Application/Control Number: 10/535,528 Page 2

## **DETAILED ACTION**

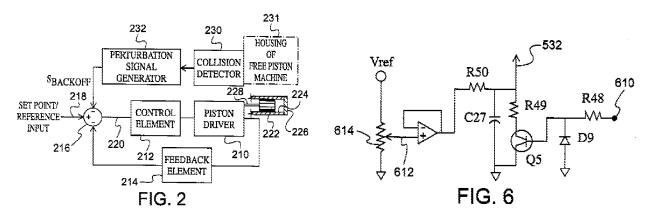
Regarding Independent **Claim 1**, and in reference to Figures 2 and 6 shown immediately above, Unger et al. (6,536,326) discloses:

As can be seen in the schematic figures shown immediately above, Unger et al.

discloses a piston control system and method of use for the particular purpose of preventing damaging collisions between the cylinder head 226 and the piston 222. In particular, Unger discloses the basic structure of the system by stating "A piston driver 210 is controlled by a control element 212, with a feedback element 214 supplying a feedback signal from the piston driver 210, or a sensor attached to detect piston or piston driver operation, to a summing junction 216 in the conventional manner. The piston driver is, of course, mechanically linked to a piston 222 for driving it. The piston 222 is slidably mounted within a cylinder 224, having a head 226 forming a cylinder end structure and connected to the piston driver by a connecting link 228. The set point is applied at the reference input 218 in the conventional manner." (Column 5, Lines 7-19) Furthermore, Unger describes (with reference to Figures 4 and 5) the feedback/control process that occurs before the creation of damaging collisions by stating "Like the circuit of FIG. 4, the circuit of FIG. 5 sums a perturbation signal with the feedback signal and the reference input signal, detects a collision of the piston against a cylinder end structure and generates a signal at an output in response to a detected collision. The circuit then varies the magnitude of the perturbation signal in the direction which reduces the piston drive in response to each detection of a collision." (Column 7, Lines 41-48). Also, Unger specifically discloses the charging and discharging of a capacitor used in a capacitor-resistor circuit. In particular, Unger discloses "When the voltage applied at terminal 610 turns off transistor Q5, capacitor C27 charges toward the voltage of the wiper 612 of potentiometer 614 at a rate determined by the resistance of resistor R50 and the upper portion of potentiometer 614. When the output of the

5. In regards to dependent **Claims 2-4, 11, & 15-16**, Unger's circuit is one that is self-feeding, contains a triggering device and bi-directional switch, and recharges a capacitor following initial discharge. With particular reference to Figure 6 above, Unger discloses a self-fed control circuit that utilizes a switching transistor unit Q5 connected
